<b>Change Number</b> M-24-00-02	<b>Federal Facility Agreement and Consent Order  Change Control Form</b> <small>Do not use blue ink. Type or print using black ink.</small>	May 22, 2001
<b>Originator</b> Jane Hedges, Ecology		<b>Phone</b> 509-736-3016
<input type="checkbox"/> I - Signatories	<input checked="" type="checkbox"/> II - Executive Manager	<input type="checkbox"/> III - Project Manager
<b>Change Title</b> Establish calendar year 2001 RCRA well installation interim milestones in support of Hanford Federal Facility Agreement and Consent Order (HFFACO) Major Milestone M-24-00M.		
<b>Description/Justification of Change</b>  <b>Introduction:</b> Regulatory requirements applicable to the generation, transport, storage, treatment, and/or disposal of hazardous and mixed wastes are established by the <i>Resource Conservation and Recovery Act of 1976 (RCRA)</i> , Washington's Hazardous Waste Management Act (HWMA), and the HFFACO, as amended. The Hanford Facility RCRA Permit was issued by the Washington State Department of Ecology (Ecology) and the United States Environmental Protection Agency (EPA) in August 1994. Ecology and EPA designated the Hanford Site as a single RCRA facility

**WMA S-SX  
Proposed Well  
Locations and  
Surrounding  
Facilities**

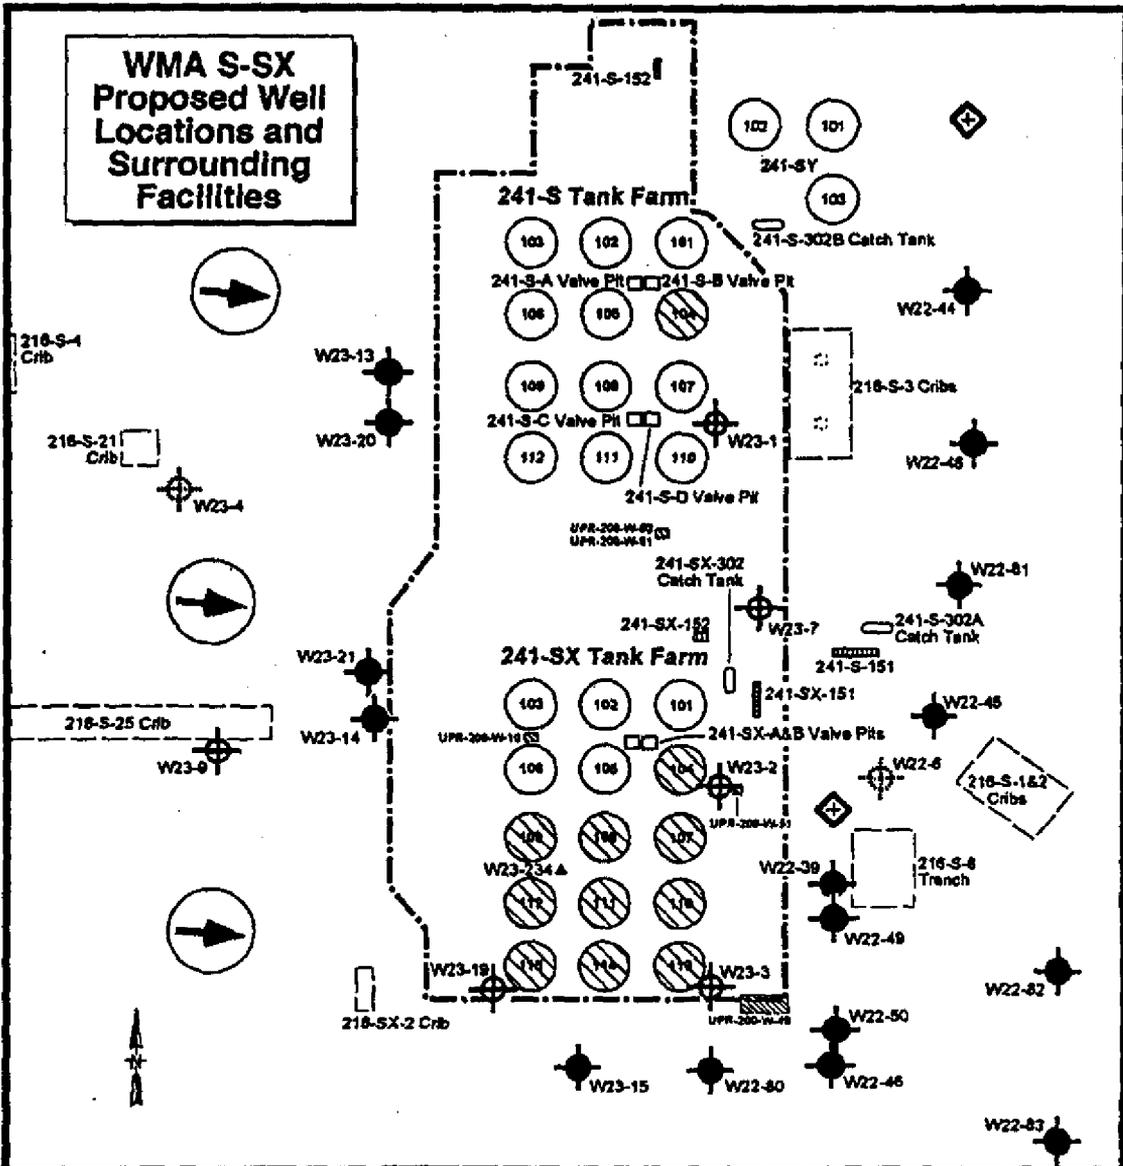
M-24-51	Install three (3) additional wells at SST WMA B-BX-BY	December 2001	Location: All wells installed downgradient at perimeter of WMA.
M-24-52	Install three (3) additional wells at SST WMA U	December 2001	Location: Two wells installed downgradient at perimeter of WMA and one well installed upgradient of WMA.
M-24-53	Install two (2) additional wells at SST WMA TX-TY	December 2001	Location: One well installed downgradient at perimeter of WMA and one well installed upgradient of WMA.
M-24-54	Install one (1) additional well at SST WMA T	December 2001	Location: One well installed upgradient of WMA.
M-24-55	Install two (2) additional wells at SST WMA S-SX	December 2001	Location: Two wells installed downgradient at perimeter of WMA.

S-SX	D	Y	0**	Site in assessment. Evaluate contaminant depth distribution. Proposed for current year drilling campaign (priority ii).	X	Downgradient assessment well southeast of facility, adjacent to mid-field well being drilled this year east of 299-W23-3.
S-SX	E	See →	Defer*	Site in assessment. Evaluate contaminant depth distribution.	X	Downgradient (perimeter), if needed. Evaluate current year's findings before deciding need/location. Part of C well cluster.
T	A	Y	3	Site in assessment. Evaluate horizontal and vertical extent of contamination.	X	Downgradient assessment well, location will be decided after data from current year's wells have been evaluated. Currently located south of the 216-T-17 Trench as a placeholder.
T	B	Y	0**	Site in assessment. Monitor contamination with depth. Proposed for current drilling campaign (priority iii).	X	Downgradient assessment well located near well #C3117 of this year's drilling.

**WMA T  
Proposed Well  
Location and  
Surrounding  
Facilities**

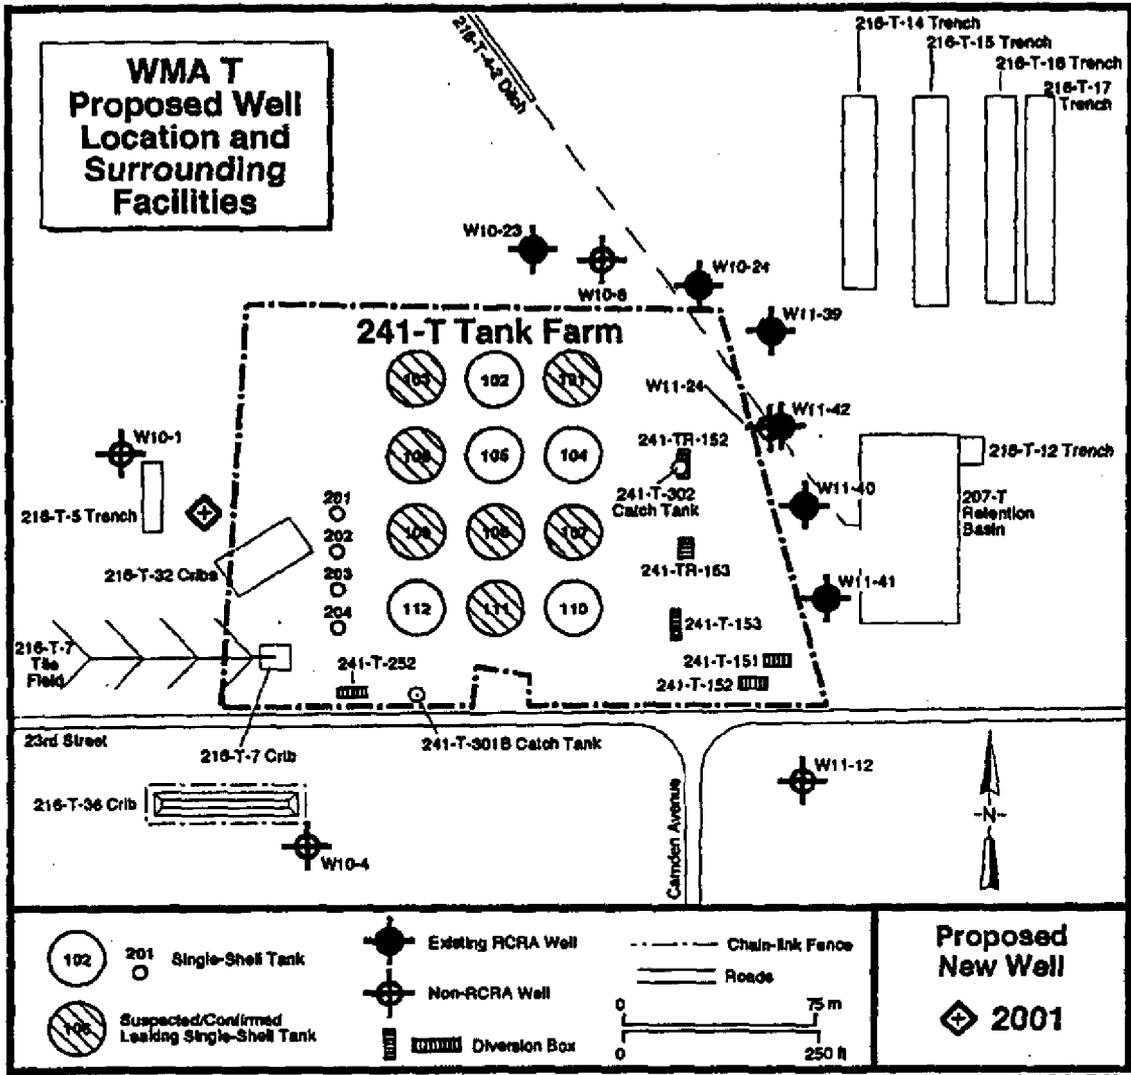
T	C	Y	2	Site in assessment. Evaluate contaminant depth distribution, monitor at depth.	X	Downgradient assessment well located near well #C3118 of this year's drilling.
T	D	Y	1	Site in assessment. Upgradient well		Upgradient. Replaces non-RCRA well 299-W10-1.
C	A	See →	Defer*	Determine flow directions, proceed step-wise.		Downgradient perimeter well.
C	B	See →	Defer*	Determine flow directions, proceed step-wise.		Downgradient perimeter well.
A-AX	A	See →	Defer*	Determine flow directions, proceed step-wise.		Downgradient perimeter well.
A-AX	B	See →	Defer*	Determine flow directions, proceed step-wise.		Downgradient perimeter well.
U-12 Crib	A	See →	Defer***	Site in assessment; non-Tank Farm site.		
U-12 Crib	B	See →	Defer***	Site in assessment; non-Tank Farm site.		
S-10 Pond	A	See →	Defer***	Site in detection; non-Tank Farm site.		
LLBG	A	See →	Defer***	Site in detection; non-Tank Farm site.		
LLBG	B	See →	Defer***	Site in detection; non-Tank Farm site.

**WMA TX-TY  
Proposed Well  
Locations and  
Surrounding  
Facilities**

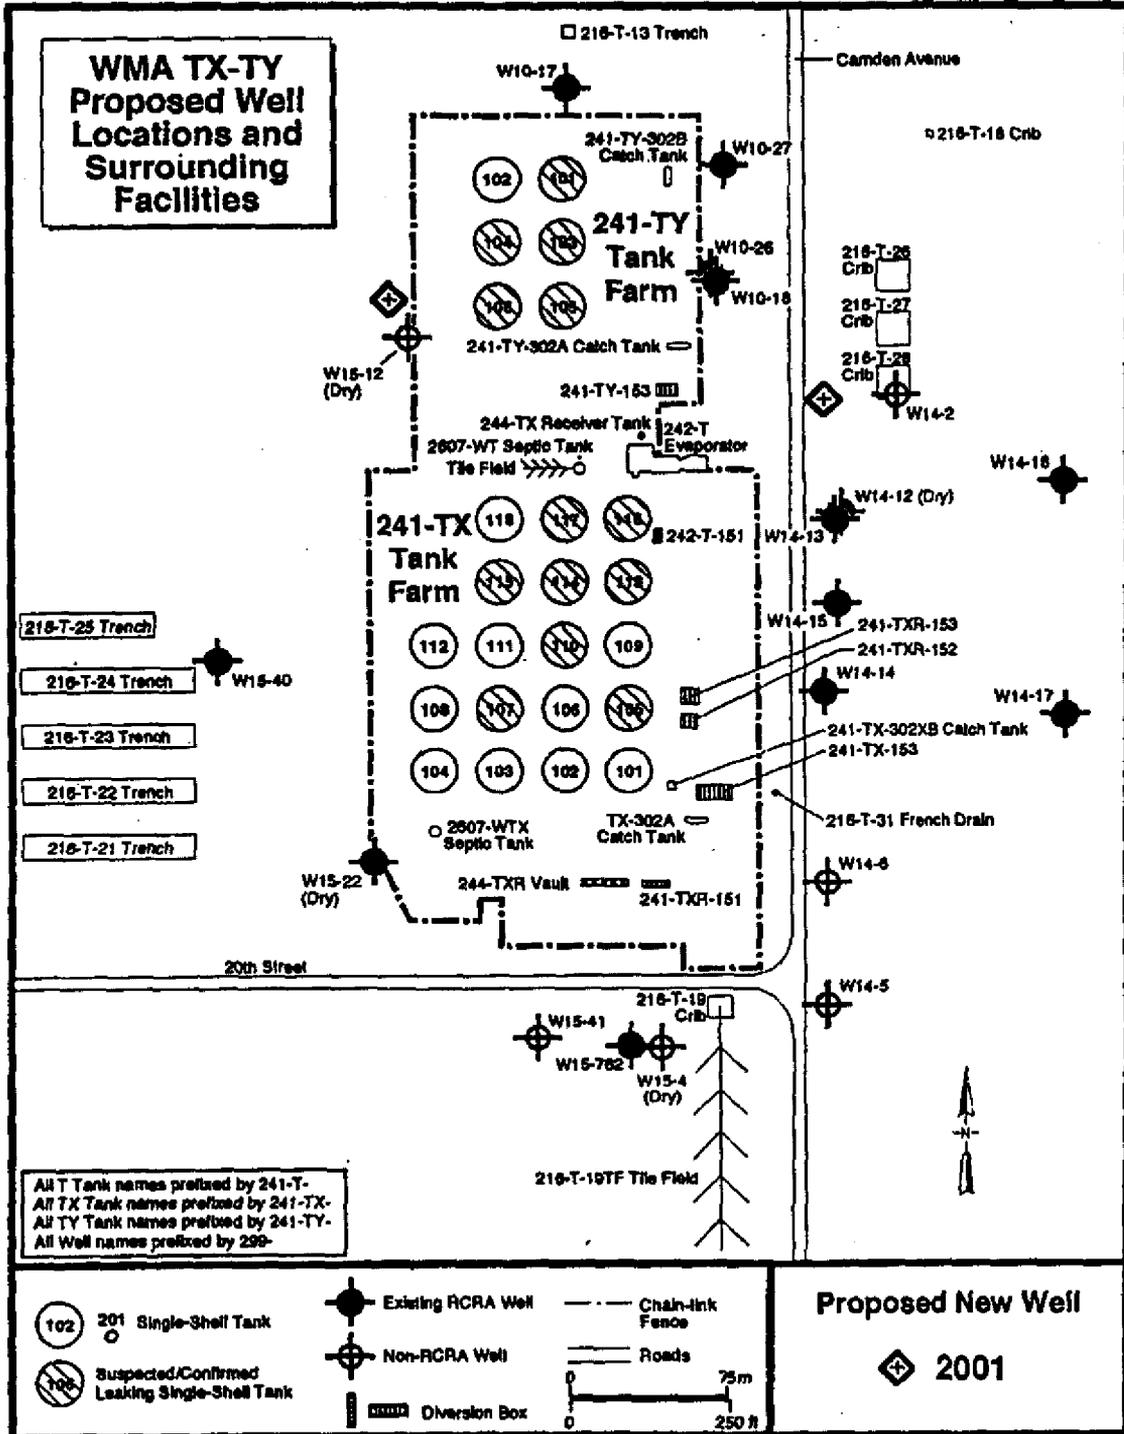
TX-TY	A	Y	1	Site in assessment. Contaminant detection/enhance downgradient coverage		Downgradient (perimeter), near non-RCRA well 299-W14-2.
TX-TY	B	Y	5	Site in assessment. Evaluate contaminant depth distribution, monitor at depth.	X	Downgradient assessment well, monitor at depth near well 299-W14-2.
TX-TY	C	Y	3	Site in assessment. Contaminant detection/enhance downgradient coverage		Downgradient (perimeter), located between wells 299-W14-6 and 299-W14-14.
TX-TY	D	Y	6	Site in assessment. Evaluate contaminant depth distribution, monitor at depth.	X	Downgradient assessment well, monitor at depth near well 299-W14-13.
TX-TY	E	Y	4	Site in assessment. Contaminant detection/enhance downgradient coverage		Downgradient (perimeter), located west of 299-W15-41.

Facility Name	Well ID	Keep on List?	Well Priority	Justification/Purpose	Deep Well	Location
TX-TY	F	Y	7	Site in assessment. Evaluate contaminant depth distribution, monitor at depth.	X	Downgradient assessment well, located adjacent to 299-W15-41.
TX-TY	G	Y	2	Site in assessment. Upgradient well		Upgradient, north end of the west side of the facility. Replaces drying well 299-W15-12.
TX-TY	H	Y (Added)	0**	Proposed for current drilling campaign (priority i).	X	Downgradient assessment well, located adjacent to newly installed well 299-W14-15.
S-SX	A	Y	1	Site in assessment. Contaminant detection/enhance downgradient coverage		Downgradient (perimeter), toward southern end of east side (well #14 on MEMO simulation).
S-SX	B	Y	2	Site in assessment. Contaminant detection/enhance downgradient coverage		Downgradient (perimeter), on northern end of east side (well #13 on MEMO simulation).
S-SX	C	See →	Defer*	Site in assessment. Contaminant detection/enhance downgradient coverage		Downgradient (perimeter), if needed. Evaluate current year's findings before deciding need/location.
